The 3-D structural geology of the PRZ

Supplementary Proof of Evidence of

Professor David Smythe

Fig. 1. Interpretation of tomogram BH5-RCF3

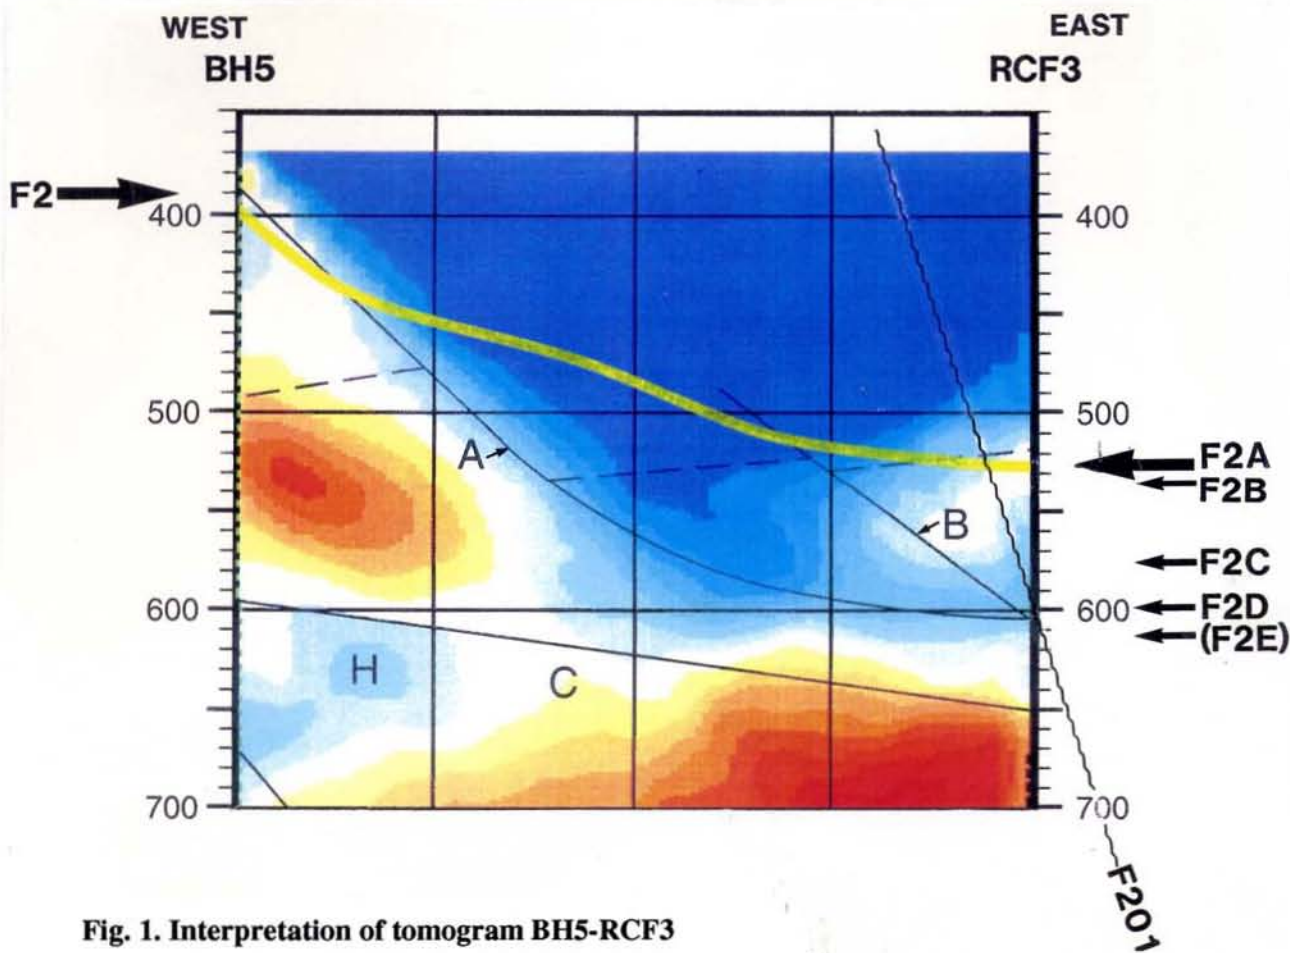
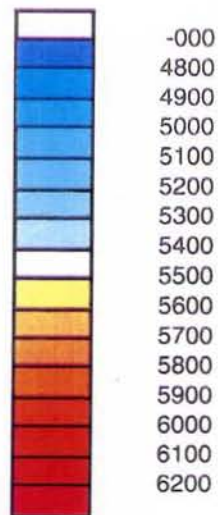
3.10 Figure 1 herein shows Nirex's preferred version of the several possible interpretations of the tomogram {S/94/007, fig. 14} [COR/513]. I have projected onto it the position of F2, derived from the borehole data and also from the seismic and other interpretations used to construct the current Nirex structural maps. Details of the projection method are given in the figure caption. The projection method results in a similar but more precise projection than may be derived from the small-scale F2 surface contour map {WA/95/47C, fig. 3.2}.

3.12 It may be seen that F2 does not correlate with any features of Figure 1. F2 cuts across features at either side of the tomogram, and runs directly across a central featureless area.

3.13 At the left-hand side (at BH5) feature A, with an apparent dip of 43°, cuts BH5 at 388 m {as described in S/94/007, p. 23, para. 4.3.7} [COR/513] corresponding to F2. However, feature A is clearly dipping at about double the angle of F2. Furthermore, where feature A intersects RCF3 it correlates precisely with F201 at around 605 mbRT of RCF3. Thus tomogram feature A starts

on the left as F2 but appears to end up on the right as F201.

3.14 At the right-hand side of Figure 1 (at RCF3), Nirex states that the principal strand of F2 (≡F2A) is at the base of the Brockram, at 527 mbRT {S/94/007 para. 4.3.1}. However, there is no feature on the tomogram which links F2A in RCF3 to F2 in BH5.

- 3.16 Fault F201, which has been identified from borehole data at RCF3, is so steep that it has not been imaged directly on the tomogram. Feature B on the preferred interpretation {S/94/007, p. 23 para. 4.3.7. and fig. 14}[COR/513] intersects RCF3 at exactly the same depth as feature A. Feature B is interpreted by Nirex as a fault. Although feature B is also at the same depth as F201, it cannot be correlated with F201 as Feature B has too shallow a dip, by a factor of about 2 (see {WA/95/47C fig. 3.5}). The structural characterisation of feature B remains unresolved.

- 3.17 Thus it may be seen that the Nirex interpretation implies that there are *three* faults all intersecting each other at around 605 mbRT in RCF3:
- The flat-lying continuation of F2 (\equiv F2E), interpreted on the tomogram,

- Fault feature B, also interpreted on the tomogram, and
 - F201, recognised in the borehole.
- This coincidence of faulting indicates the complexity of the PRZ.

- 3.18 Nirex states that the lowest strand of F2 (\equiv F2E) is missing at RCF3 because it has been cut out by F201 {S/95/007 fig. 5.2}. F2E appears to match the BH5-RCF3 tomogram correlation better than the Nirex mapping of F2 at F2A (88 m above F2E).
- 3.19 A revised mapping of 'F2' over the PRZ, using F2E rather than F2A would create its own problems, due to the implications it would have for the variety of trends of F2 over the PRZ. Correlation of the three lowest strands of F2 between the trio of boreholes RCF3-RCM2-RCM1 {S/95/007} suggests that the three strands dip steeply north (F2C) or NW (F2D and F2E). The correlations are illustrated in Figure 2. This three-way borehole correlation would require F2 to swing anticlockwise through 90°, and then back again to account for the faulting in the area of RCF3. This would be highly unusual behaviour for a normal fault such as F2.
